**From:** Bridge Clean Air <bridge@cacwny.org>  
**Sent:** Friday, March 29, 2024 3:33 PM  
**To:** Mcpherson, Benjamin J (DEC)  
**Subject:** Site 109 Operable Unit 02 Amended Remedy Comment

## Technical Memorandum

### **Review of Proposed Amendment for Public Comment NYSDEC Site No. 915055 TONAWANDA COKE SITE – OPERABLE UNIT 2 (Site 109)**

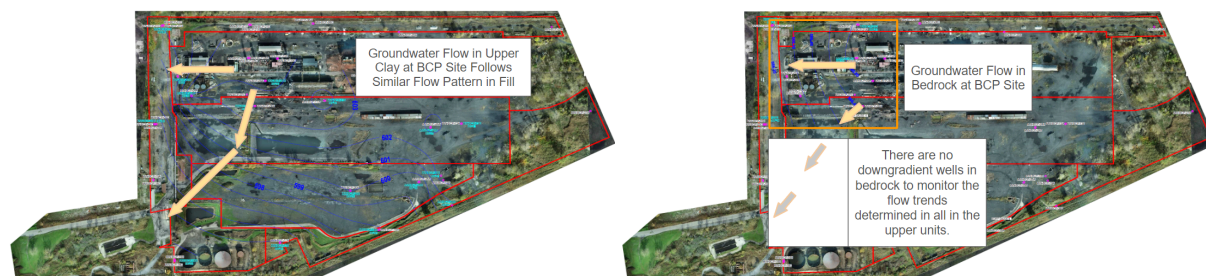
Following the path from the major contaminant source locations in the production areas at the Tonawanda Coke BCP Site and noting the relatively high level of the contamination of the fill in these areas, the presence of contaminants in the clay water-bearing zone was examined to uncover whether the clay zone has been contaminated. In particular, some of the exceedances of class GA groundwater standards in the upper clay included:

- AOI-1 Phenol, Chromium, and Arsenic
- AOI-2 Chromium, and Arsenic
- AOI-4 Volatile and Semivolatile Organic Compounds, Chromium, Arsenic and Mercury
- AOI-5 Volatile and Semivolatile Organic Compounds, Chromium, Arsenic and Ammonia
- AOI-7 Volatile and Semivolatile Organic Compounds

In the RIR, the permeabilities for clay samples in the upper clay unit were measured to be in the range of  $10^{-8}$  centimeters per second (cm/s), which were somewhat consistent with the results of  $10^{-6}$  cm/s to  $10^{-8}$  cm/s reported in the Supplementary Site Investigation (SSI) Report dated July 1990 prepared by Conestoga-Rovers & Associates (CRA, 1990), although the lower end of the permeability of  $10^{-6}$  by CRA indicates the possibility for a geometric increase in contaminant travel time. The RIR indicated that several core samples retrieved from the upper clay exhibited vertical "desiccation" cracks; it is not uncommon for such cracks to form conduits for vertical migration. So, while the low permeability of the clay would be expected to act as an aquiclude to prevent downward migration of contaminants, the presence of these compounds indicates that this layer is leaky.

Recommendation: Place additional nested wells upgradient at Site 109 into clay and bedrock units to monitor for the transgression of groundwater contamination onto the site from the Tonawanda Coke BCP Site. Add the installation and monitoring into the remedy as well as the Site Management Plan and include monitoring for the same suite of compounds analyzed at the Tonawanda Coke BCP Site.

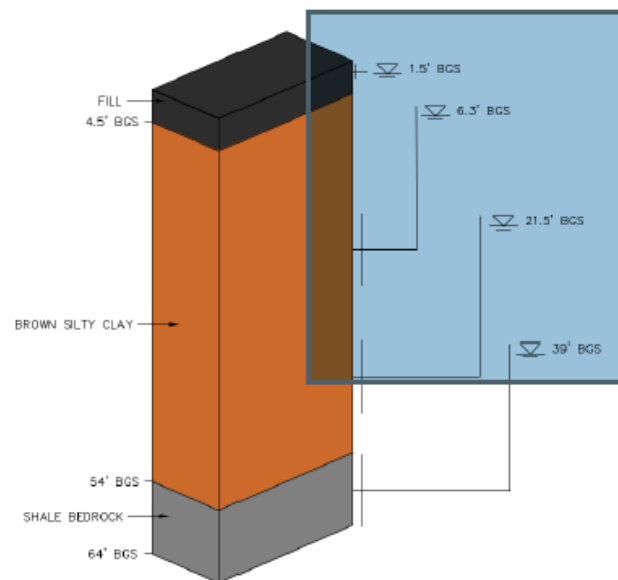
Groundwater flow in the fill generally follows the top of the clay layer reported in the RIR as shown below.

Groundwater flow in the Upper and Lower Clay Units follow the same pattern as shown below.

In any event, horizontal flow gradients were measured to determine components of groundwater flow using the above flow maps with the following results:

- 0.0025 Horizontal Gradient in Fill
- 0.011 Horizontal Gradient in Upper Clay
- 0.011 Horizontal Gradient in Lower Clay
- 0.00025 Horizontal Gradient in Bedrock

The results suggest that the lowest horizontal gradients are present in the fill and that horizontal gradients are one to two orders of magnitude higher in the combined clay unit. Data showing vertical heads in hydrogeological units at the Tonawanda Coke BCP Site were provided in the following figure in the RIR:

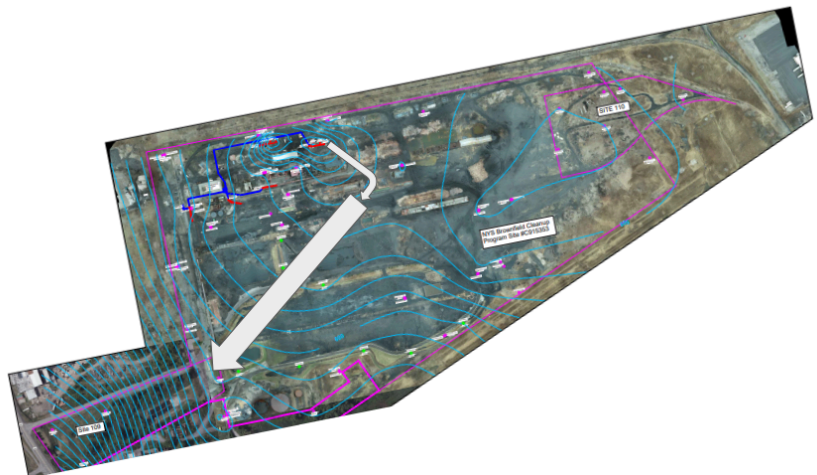
The vertical gradient across the clay was calculated from the above figure to be 0.758 in the downward direction, orders of magnitude greater than any horizontal gradients measured at the site. Using the thickness reported above, this results in a flow of 0.79 feet per year in a downward direction. Given the approximate dates of likely releases during facility operations, and, given the current contaminant distribution in the clay unit, contaminants could be expected to enter the bedrock flow regime at some point in the future. In summary, contaminant transport could look like this:
